15. TRANSIENT AND ACCIDENT ANALYSES

The staff of the U.S. Nuclear Regulatory Commission (NRC) has reviewed the AP1000 transient and accident analyses in the DCD, in accordance with Chapter 15, "Accident Analysis," of NUREG-0800, which defines the agency's Standard Review Plan (SRP).

Pressure Drop vs Core Steaming Rate

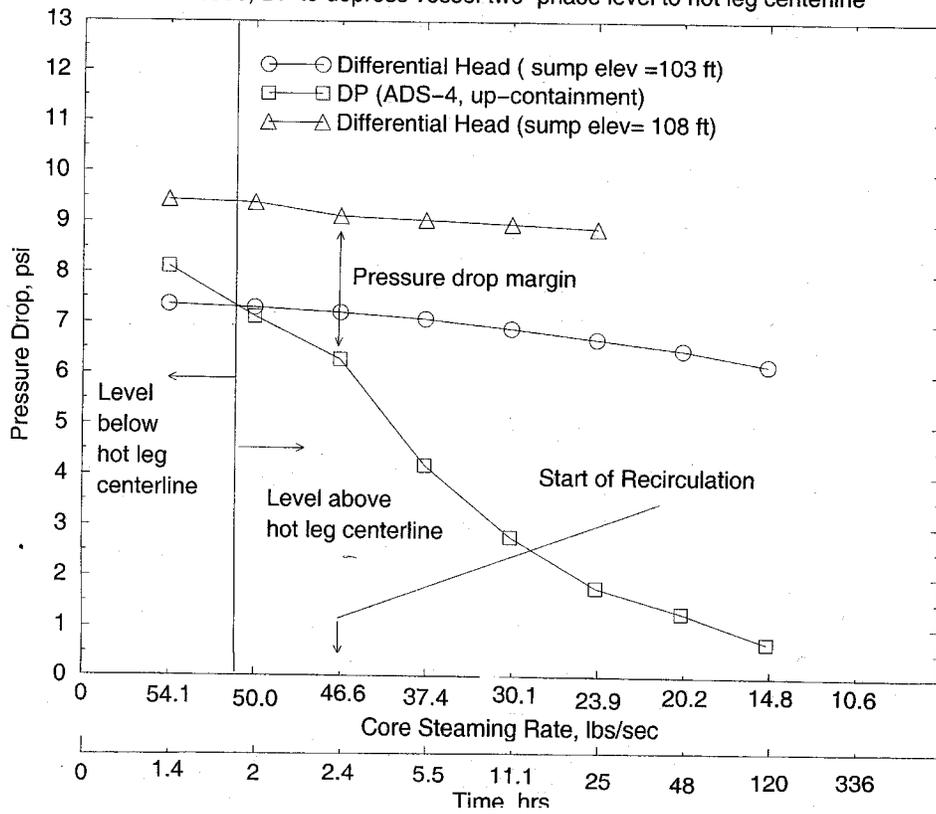
Using the staff methodology described above, Figure 15.2.7.6 of this report compares the calculated hydrostatic head differentials between the sump/downcomer and inner vessel, covering the range of decay heat steaming rates from 25 kg/s to 5 kg/s (54.1 lb/s to 10.6 lb/s) (1.4 h to 14 days). The start of recirculation is 8640 seconds (2.4 h), with a steaming rate in the core of 21 kg/s (46.1 lb/s). Figure 15.2.7.6 of this report compares the head differential to the pressure drop across the ADS-4 lines over these decay heat generation rates. The two-phase level would be at the hot-leg centerline elevation only when the pressure loss across the ADS-4 lines equals the differential head of water between the sump/downcomer and inner vessel region. Clearly, when the ADS-4 pressure loss exceeds the differential head curve in Figure 15.2.7.6 of this report, the pressure loss across the ADS-4 lines is high enough to depress the two-phase level below the centerline of the hot-leg. In Figure 15.2.7.6 of this report, the vertical line indicates this condition so that, for steaming rates of about 23 kg/s (50 lb/s) and higher, the two-phase level will be depressed below the hot-leg centerline if only pure steam (quality = 1.0) should exit the system. The region to the right of the vertical line demonstrates that when only single vapor exits the ADS-4 lines, the pressure loss across the ADS-4 lines is insufficient to depress the two-phase level below the centerline of the hot-leg.

Furthermore, if the minimum sump level computed by Westinghouse based on conservative assumptions regarding containment performance is used, even more margin is available to guarantee the expulsion of liquid from the RCS. Bounding containment calculations by Westinghouse show that the sump level at 2.4 hours is at Elevation 32.9 m (108 ft) in the containment (higher than the assumed Elevation 31.4 m (103 ft) in the staff analysis). Using the sump level of 32.9 m (108 ft) at 2.4 hours which decreases to 32.6 m (107 ft) at 1 day, as shown in Figure 15.2.7.6 of this report, at the earliest time of recirculation (2.4 h), a margin of approximately 20.7-kPa (3-psi) in the pressure loss is required to depress the two-phase level below the hot-leg centerline. This water is also subcooled, but the Figure 15.2.7.6 analyses did not credit it. Subcooling would further increase the excess margin, as would higher containment pressures, because at 2.4 hours the minimum containment pressure is 131 kPa (19 psia). At these low pressures, an increase from the assumed 101.4 kPa (14.7 psia) containment pressure to the minimum justified pressure of 131 kPa (19 psia) would further reduce the pressure loss across the ADS-4 lines, since the pressure drop would decrease because of the lower steam specific volume at the higher pressures. Clearly, excess margin exists to cover uncertainty in the pressure losses in the ADS-4 lines (uncertainty in the CRANE resistances and unknown variations in the line resistance set up possibly by the interactions between two closely connected elbows or bends), as well as any additional uncertainty that may exist in the line resistances connecting the sump to the downcomer. Figure 15.2.7.6 of this report shows that, at the start of recirculation (2.4 h), a 20.7 kPa (3 psi) margin exists. This estimate is conservative because it did not credit subcooling and neglected the benefit of the higher containment pressure of 131 kPa (19 psia).

Lastly, this excess margin can also accommodate compressible effects. Crane shows that a compressible factor of 1/0.87 should be applied to the pressure drop when the hot-leg is at 137.9 kPa (20 psia), and the steam flow rate through one hot-leg is 13.61 kg/s (30 lb/s). The excessive margin shown in Figure 15.2.7.6 of this report more than sufficiently covers increases in the pressure drop from compressibility effects.

In view of these results, sufficient margin in the AP1000 design exists to assure that liquid will be expelled from the RCS through the ADS-4 lines for as long as 14 days following reactor trip. In fact, because of the excess margin displayed in Figure 15.2.7.6 of this report, two-phase fluid would be expected to spill from the RCS through the ADS-4 lines well beyond the 14-day period illustrated in this graph. Even as late as 14 days, ERGs will require the operators to take actions to secure the plant. These actions include raising the sump level to the elevation between 33.2 m (109 ft) and 33.5 m (110 ft) by filling the containment sump with subcooled water from the RNS. This action would ensure liquid expulsion from the RCS for an extended period of time and would ensure that the steaming rate in the core would be terminated
